**TOWN OF BAY HARBOR ISLANDS
PLANNING AND ZONING BOARD**

FINAL AGENDA

**TOWN OF BAY HARBOR ISLANDS
COMMUNITY DEVELOPMENT
MEMORANDUM**

Subject: Proposed Single-Family Residence - (Second Review)
Applicant – Robyn Seiden / Matthew Shear
1288 101st Street
Bay Harbor Islands Acct. No.: BP2013-299
MMPA Acct. No.: 01-0702-0978

NORTH (FRONT) ELEVATION

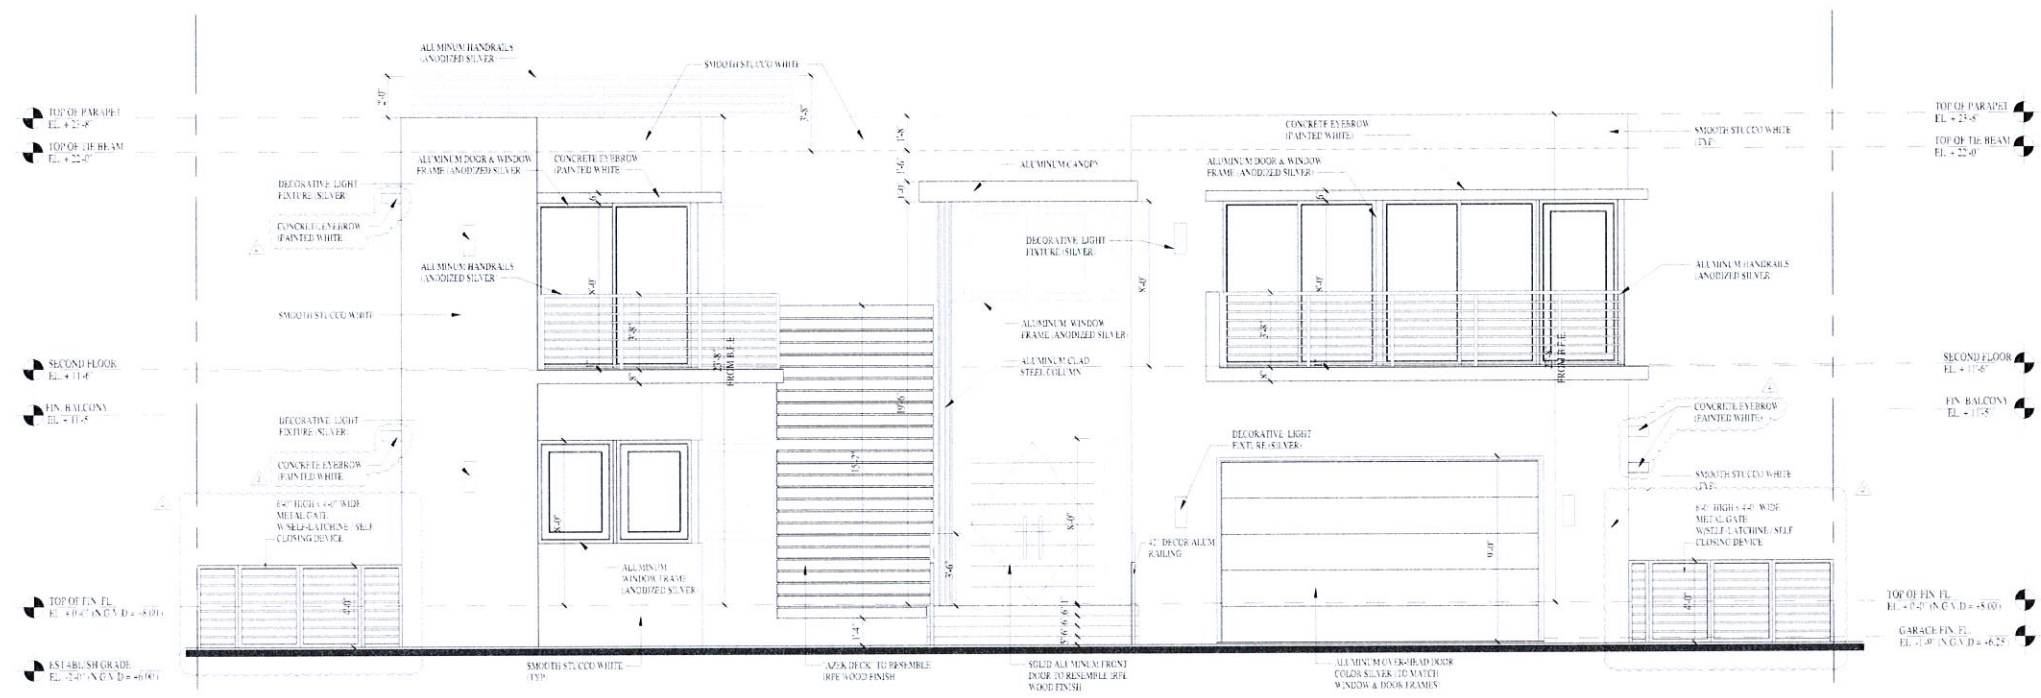
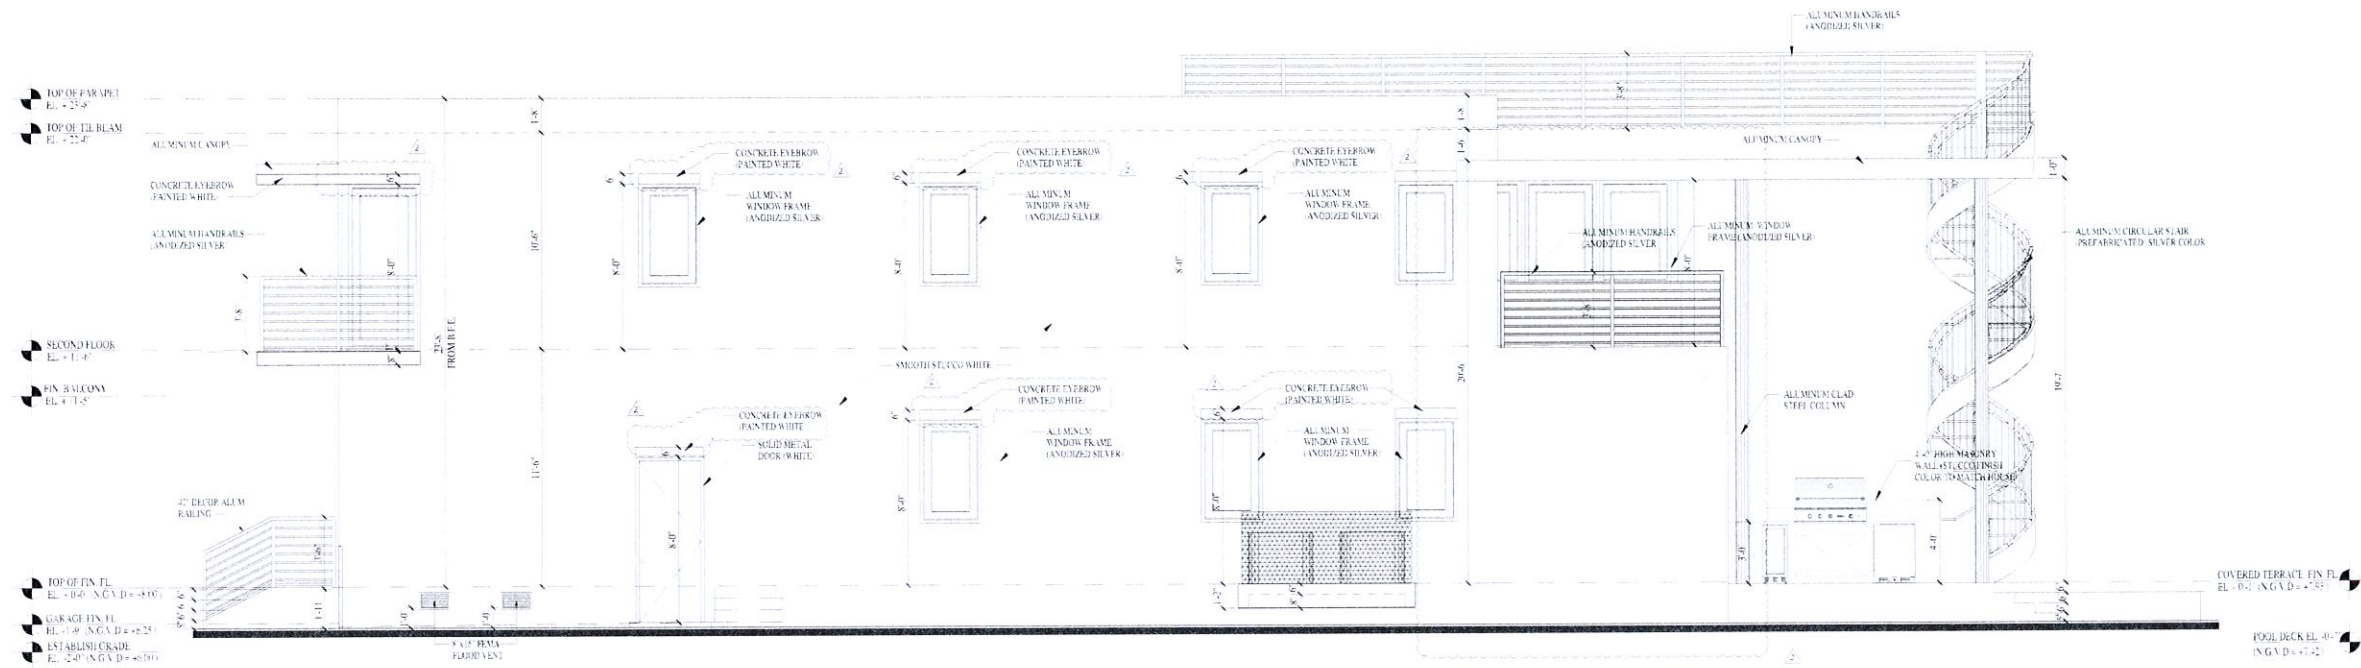
- Eyebrows have been added to the windows in addition to balconies in the front of the building. These balconies meet the Town Code requirements as they do not project into the front yard setback.
- The landscape plans have been enhanced. A continuous hedge line has been added along the side property lines. Additionally, several tree species have been added / altered.
- The square footage of the house has increased slightly with the addition / enlargement of the cabana bath and guest room in the rear of the property on the first floor. This new area meets all setback requirements.
- The swimming pool design has changed slightly.
- "Balcony 3" on Sheet A-3 has been enlarged. This also meets the Town Code as it does not project into any setback.
- The west elevation has changed slightly. Previously, this area "bumped-in" on the second floor (now a continuous plane).
